Access Compliance Report

Public Rights-of-Way

(Curb Ramps)

Intersection ID: 13806	Main Street: S_TRYON_ST	Cross Street: WEST_BV	Location: W
ADA ID: D3C5F34CB0E2	Ramp Type: Perp	Initial Pass/Fail: Fail	Overall Compliance: No
Severity Score: 35			
Codes/Mitigation Info/Possible Solution		Field Measurements/Component Compliance

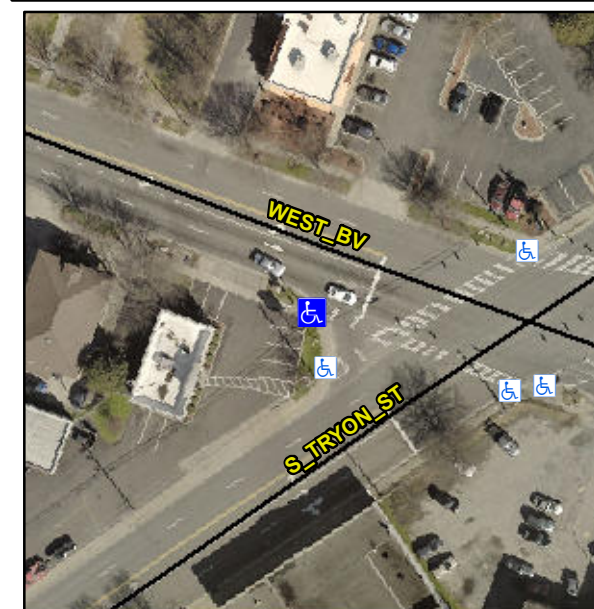
Not Found, R304.5.1, R304.2.2, R304.5.3

Compliance	Description	Data	Compliance	Description	Data
N/A	Ramp Length (in)	74.0	No	Ramp Slope (%)	12.7
No	Ramp Width (in)	43.0	No	Ramp XSlope (%)	4.2
N/A	Flare Type LT	N/A	N/A	Flare Type RT	N/A
N/A	Flare Slope LT (%)	N/A	N/A	Flare Slope RT (%)	N/A
N/A	Flare Traversable LT?	N/A	N/A	Flare Traversable RT?	N/A
N/A	Landing Length (in)	N/A	N/A	DWS Provided?	N/A
N/A	Landing Width (in)	N/A	N/A	DWS Contrast?	N/A
N/A	Landing Slope (%)	N/A	N/A	DWS Length (in)	N/A
N/A	Landing X Slope (%)	N/A	N/A	DWS Full Width?	N/A
N/A	Landing Curb? (Y/N)	N/A	N/A	DWS Offset (in)	N/A
N/A	Shared Landing?	N/A			
N/A	Gutter Ponding?	N/A	N/A	Gutter Slope (%)	N/A
N/A	Gutter Lip Ht (in)	N/A	N/A	Gutter X Slope (%)	N/A
N/A	Painted X Walk1?	Yes	N/A	Painted X Walk2?	N/A
	X Walk 1 Direction	To SE		X Walk 2 Direction	N/A
N/A	X Walk 1 Width (in)	70.0	N/A	X Walk 2 Width (in)	N/A
	X Walk 1 Slope (%)	3.5		X Walk 2 Slope (%)	N/A
	X Walk 1 X Slope (%)	4.1		X Walk 2 X Slope (%)	N/A

Remove & Replace Entire Ramp.
